# SERVICE BULLETIN - OPTIONAL

Part No.: P122

Description: Avionics Switch Console	Service Bulletin No.: P122-603-0001
Service Manual: N/A	Subject: Linear Grommet Inspection & Retrofit
ECO No.: 1165

Figure 3 — Overview of Grommet Locations

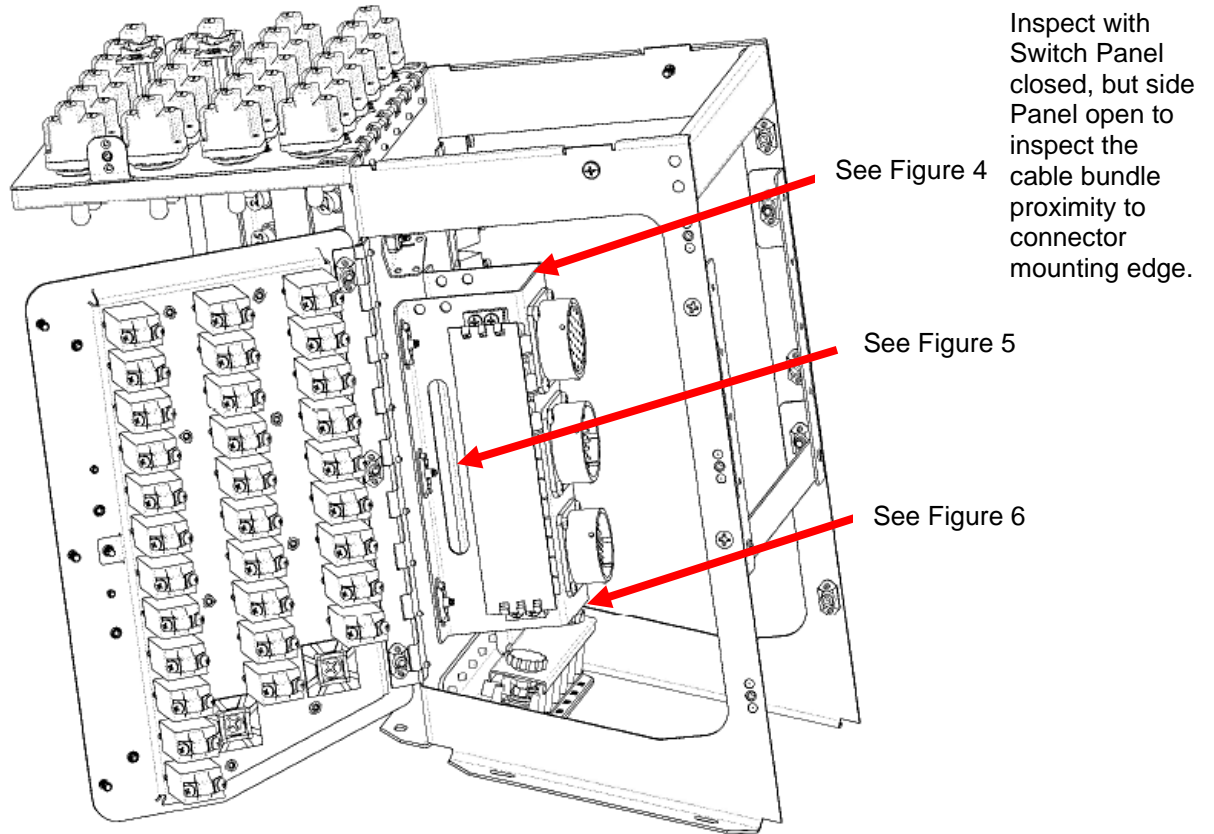
Referencing Figure 3 through Figure 6, inspect the Connector Bracket Assembly for the linear grommets identified by red arrows. Use an inspection mirror as required.

If all or some of the grommets identified in Section 2 Procedure for Inspection are missing, inspect the adjacent wire bundles for chafing and damage. Use an inspection mirror where required. If damage is found stop and contact AEM for return of the P122 Avionics Switch Console for warranty servicing.

If none of the wire bundles are damaged, referencing Figure 3, through Figure 6, install the linear grommets identified by red arrows. Use an inspection mirror as required to confirm fit. 2-inch long grommets are installed in Figure 4 and Figure 6, 3-inch long grommets are installed in Figure 5.
